Product Change Notification (PCN)

PCN #: 3A-2025

Date: March 5, 2025

Ezurio Part Number	Description
453-00199R	Module, Sona TI351, MHF4, Tape and Reel
453-00199C	Module, Sona TI351, MHF4, Cut Tape
453-00200R	Module, Sona TI351, Integrated Antenna, Tape and Reel
453-00200C	Module, Sona TI351, Integrated Antenna, Cut Tape
453-00209	Module, Sona TI351, M.2 2230

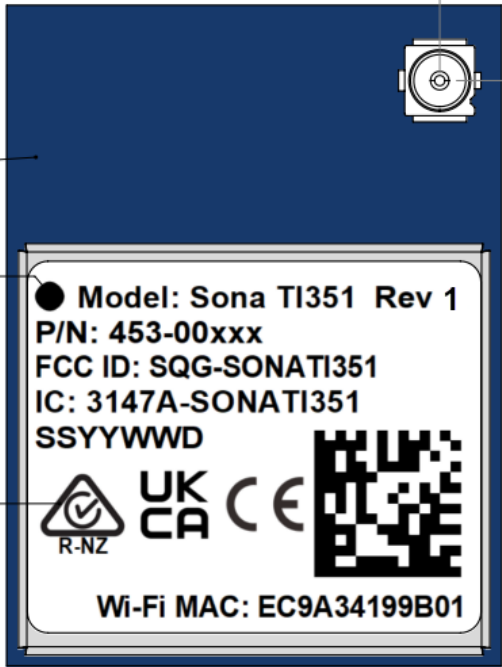
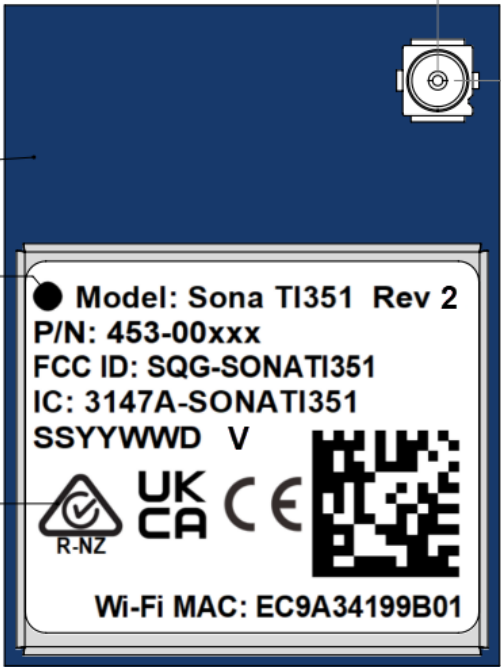
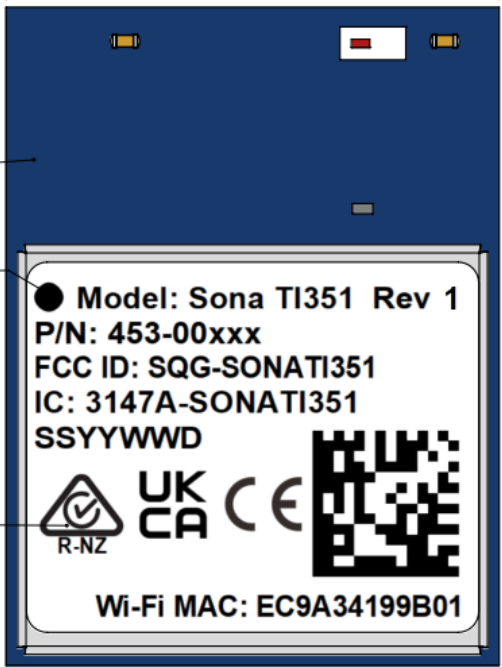
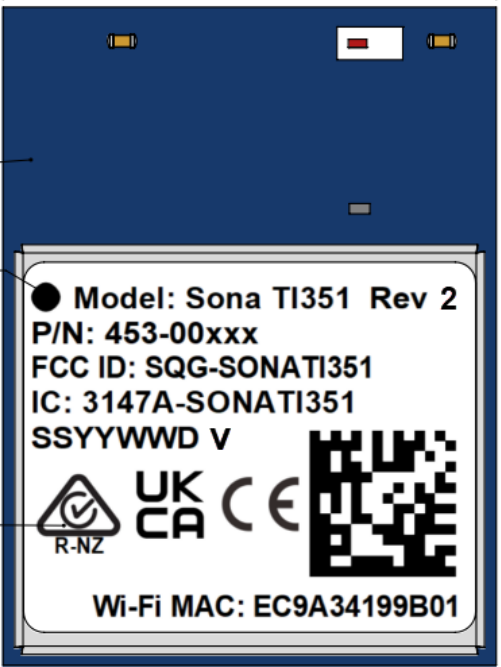
- Update PCB silkscreen revision if applicable
- Update revision and add COO identification "V" on the product label
- Update revision and COO on the package labels

- To address the UART line swapping issue to comply with PCIE M.2 specification footprint for the 1216 LGA.
- Change the COO from China to Vietnam

- The swapped UART lines mean the device pinout is not compliant with the published specification. The device can be made functional by adjusting the pinout on the target system, however this will only apply to the products covered by this PCN. The affected product should be replaced.

- **453-00199R/453-00199C/453-00200R/453-00200C**
 - On the module product label, change the revision from Rev 1 to Rev 2, and add the COO identification "V".
 - On the packaging labels, change the revision from Rev 1 to Rev 2. Change COO from CN to VN.
